Basis of this breakdown

NORTHERN WOLVES AC

Snowflake Fitout - 7 Times Square, Floors 29-31 | COP-SF-05 Bulletin 3 Revision

Area 29-1 - North supply main - reroute through existing beam cuts

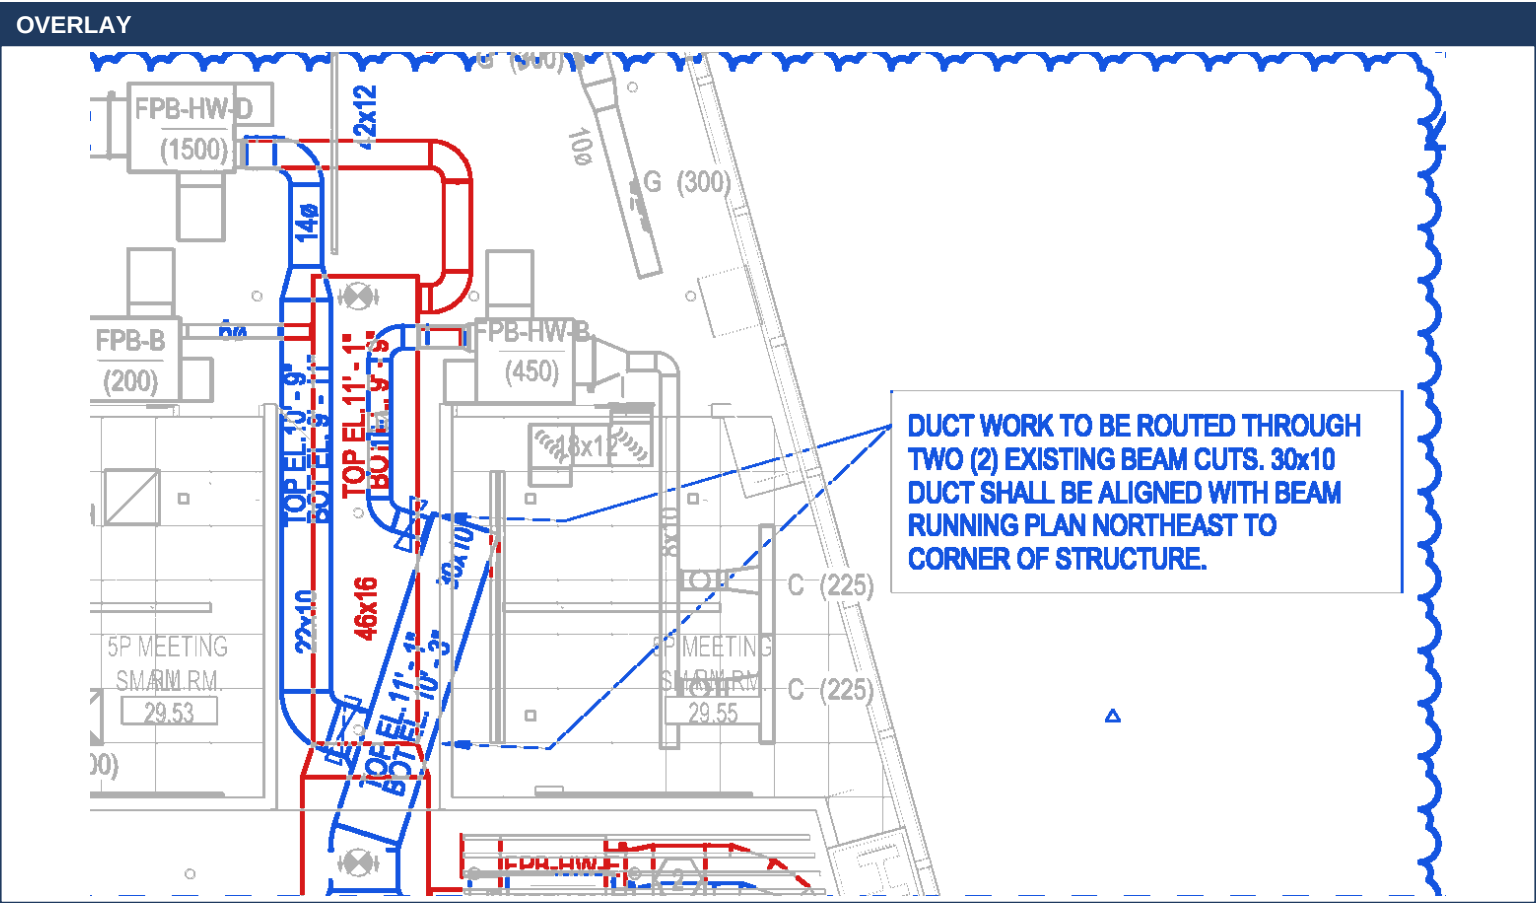
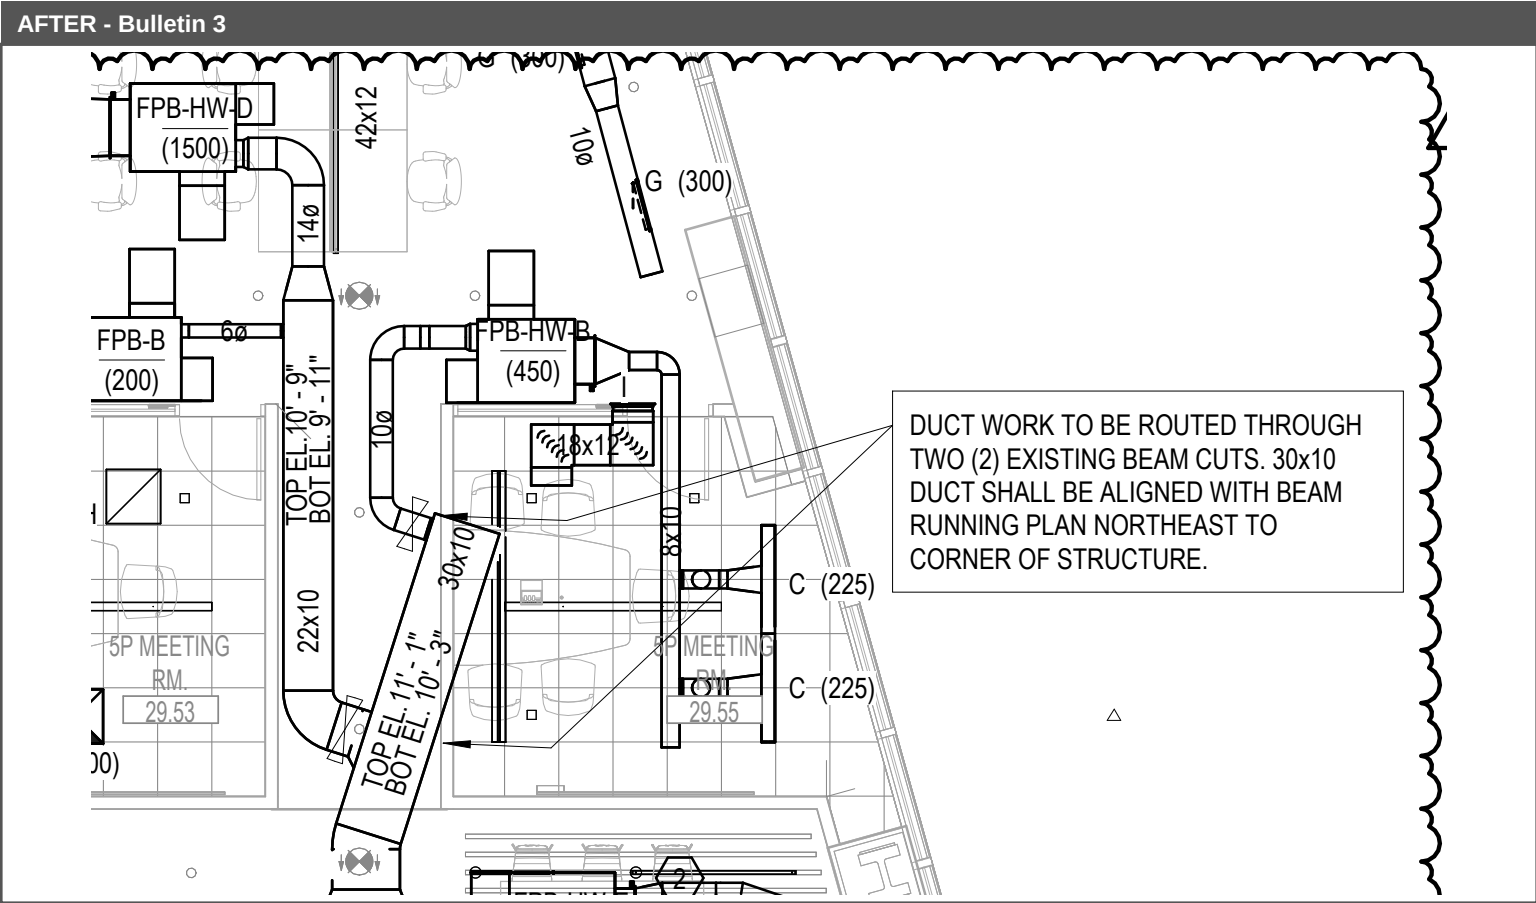
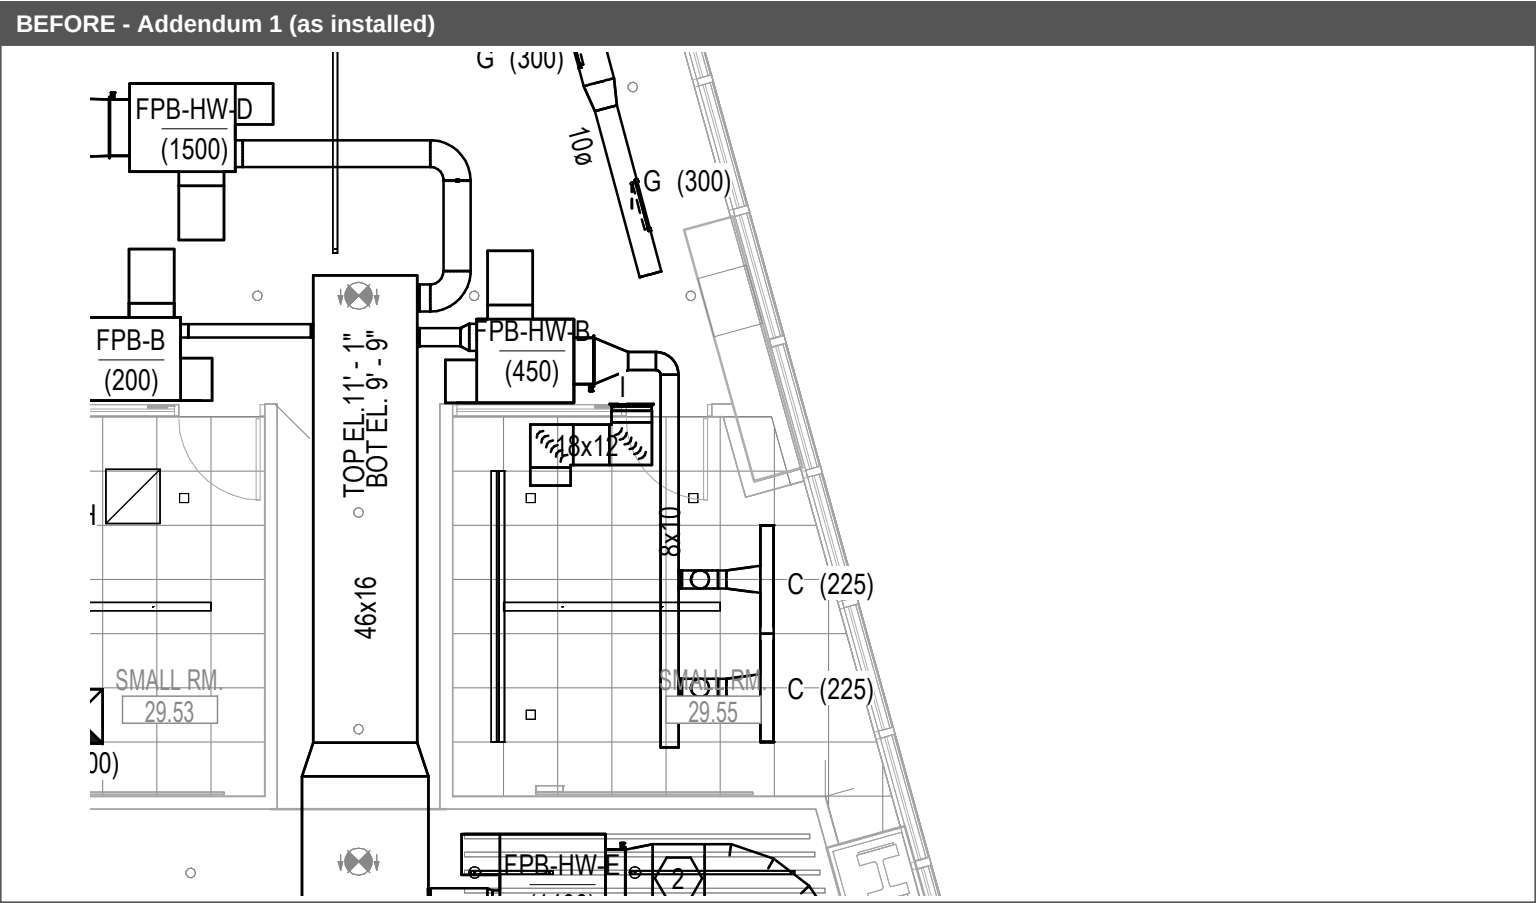
Before (Addendum 1, installed): 46x16 supply main (approx. 20 LF, bottom el. 9'-9") with branch connections to FPB-HW-D (1500), FPB-HW-B (450) and FPB-B (200).

After (Bulletin 3): Main rerouted as 22x10 and 30x10 through (2) existing beam cuts, 30x10 aligned with the beam running plan northeast. New 14x10 branch to FPB-HW-D, 10x10 to FPB-HW-B and 6x10 to FPB-B.

Work required: Disconnect and remove installed 46x16 section and branch connections. Fabricate and install 22x10 / 30x10 duct and round branches with insulation, reconnect terminal units.

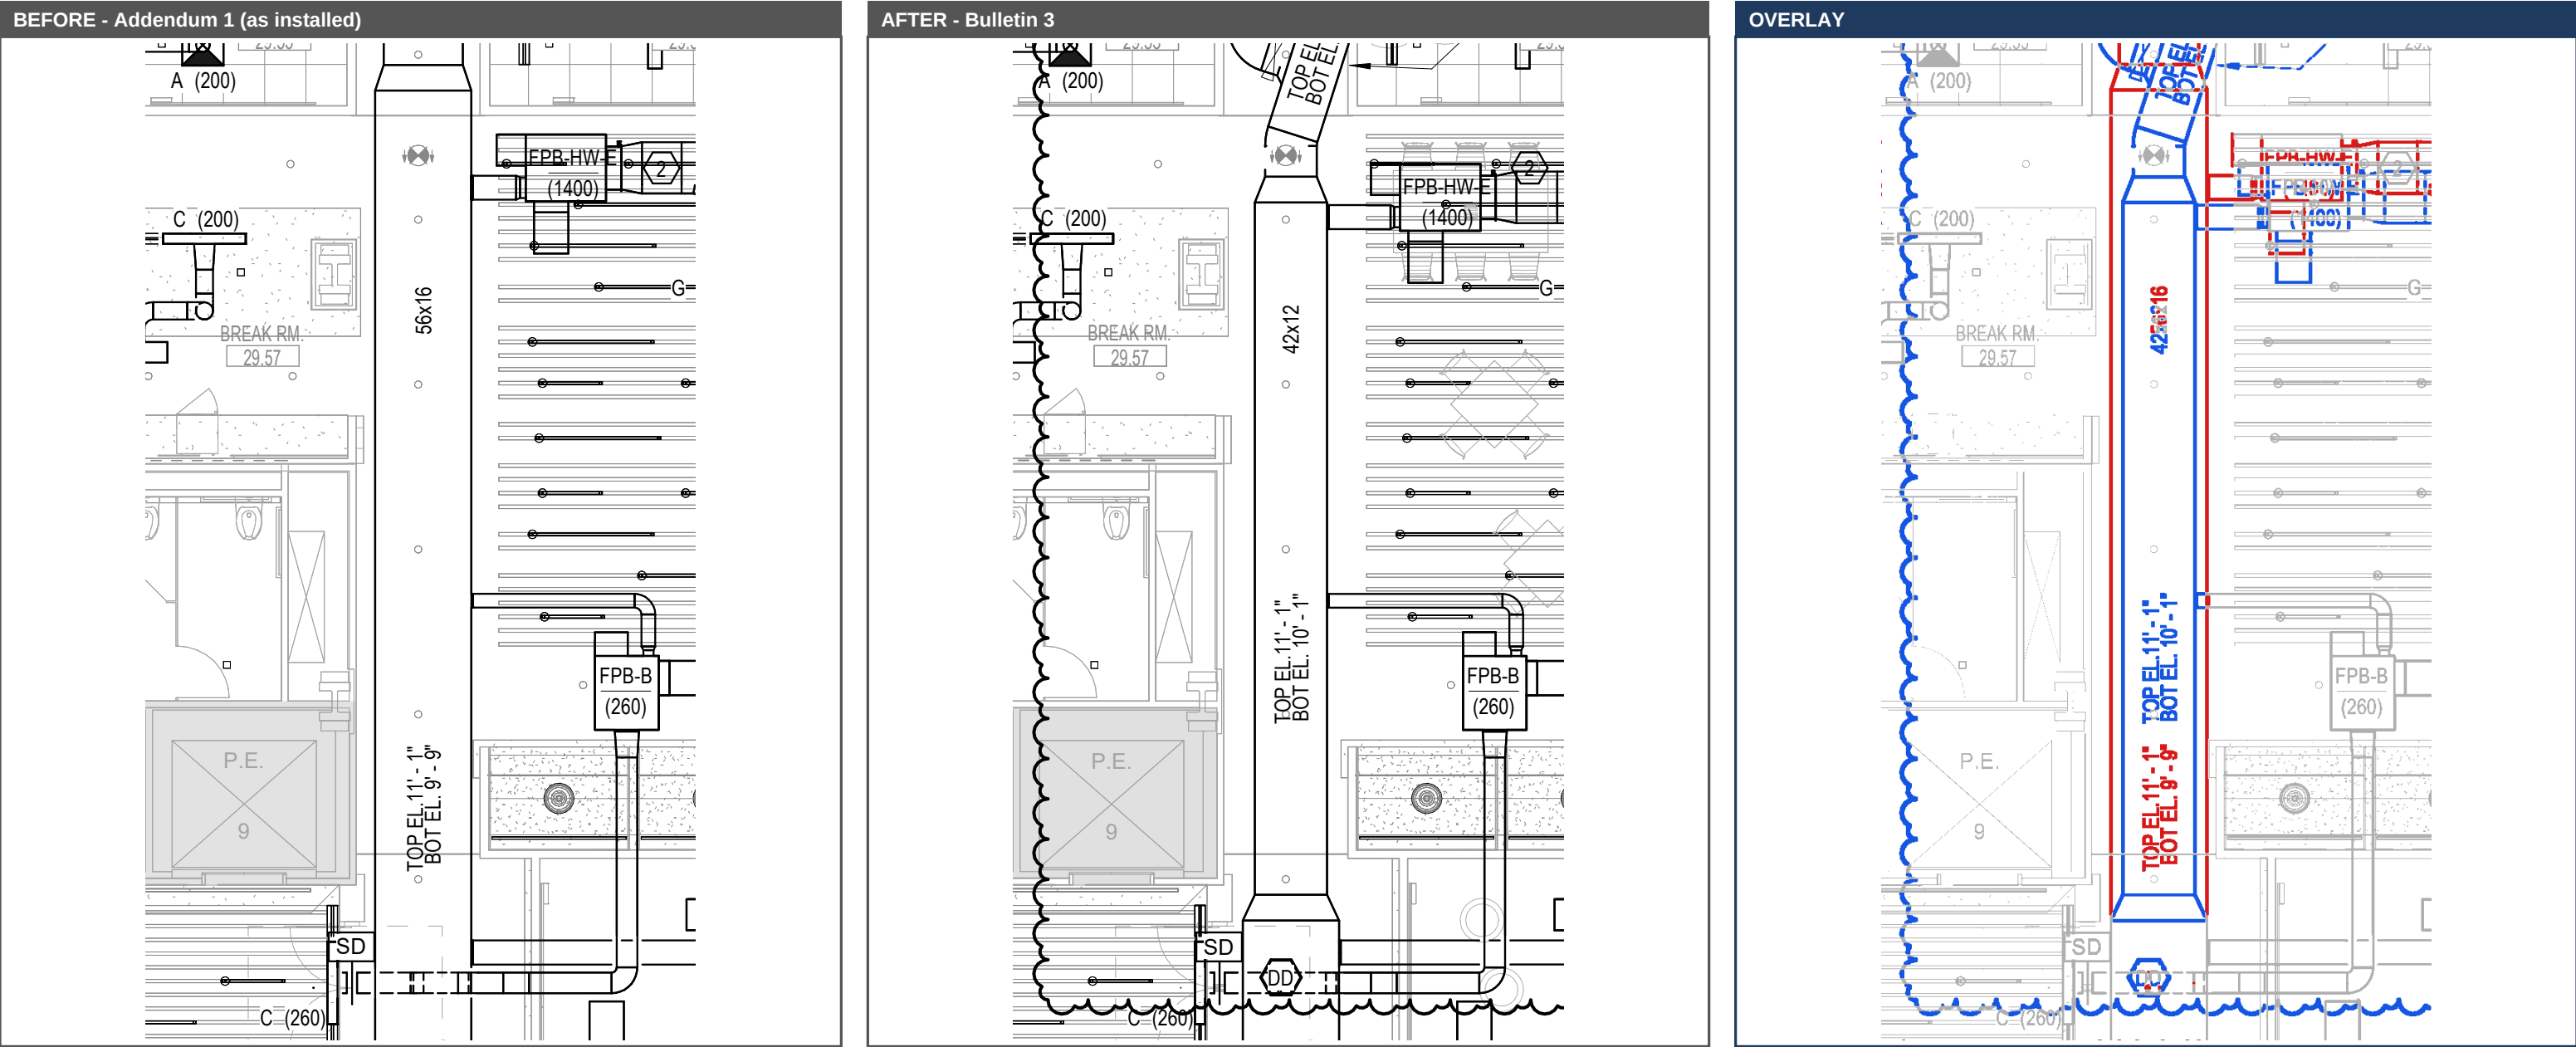
Before (Addendum 1, installed): 56x16 supply main, approx. 44 LF, top el. 11'-1" / bottom el. 9'-9", Break Rm 29.57 to P.E.

After (Bulletin 3): Main resized to 42x12 on the same route, top el. 11'-1" / bottom el. 10'-1".

Work required: Disconnect and remove installed 56x16 main. Fabricate and install 42x12 main with insulation, reconnect branch takeoffs (FPB-HW-E, FPB-B (260)).

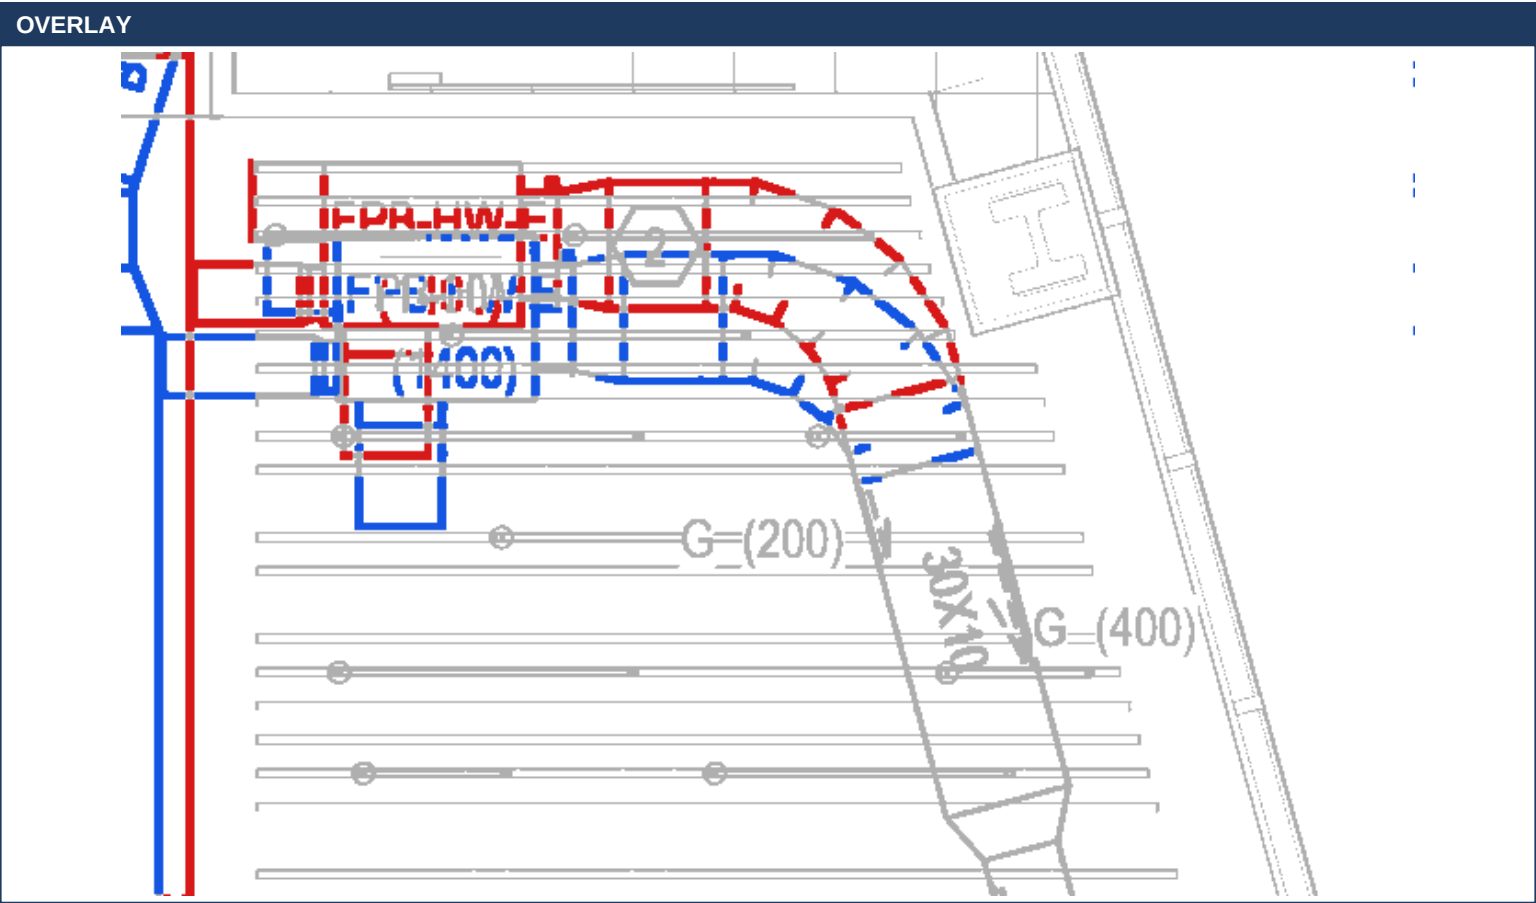
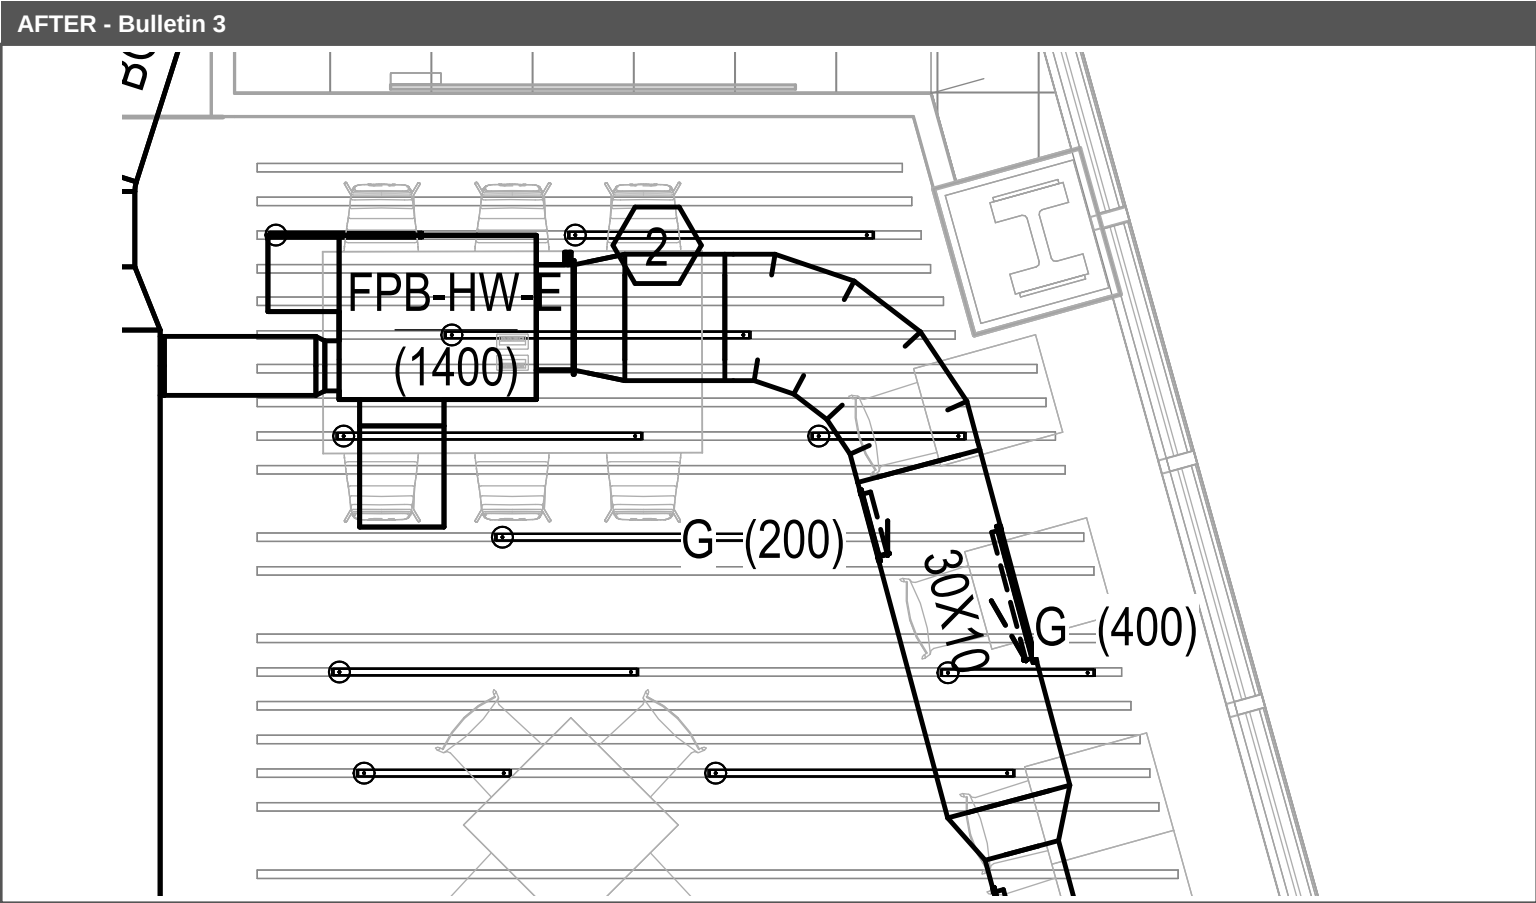
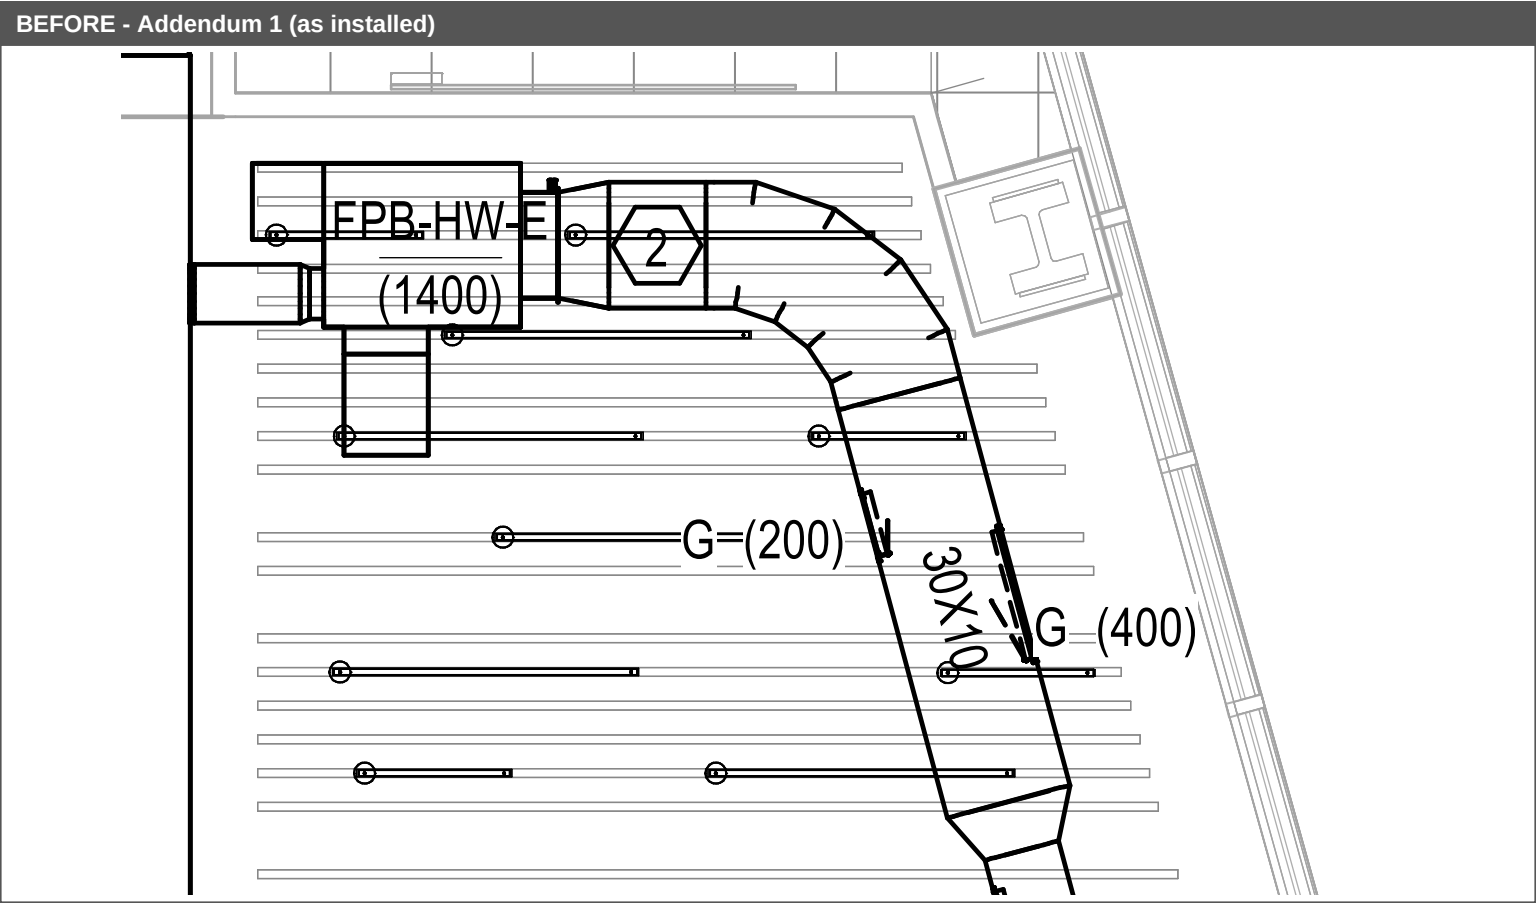
Before (Addendum 1, installed): FPB-HW-E (1400) with inlet and 30x10 discharge to the G(400) / G(200) linear diffusers along the northeast wall.

After (Bulletin 3): FPB-HW-E relocated; inlet connection and 30x10 discharge elbow rerouted.

Work required: Disconnect inlet and discharge, relocate and rehang FPB-HW-E, fabricate and install new inlet and 30x10 discharge fittings, reconnect.
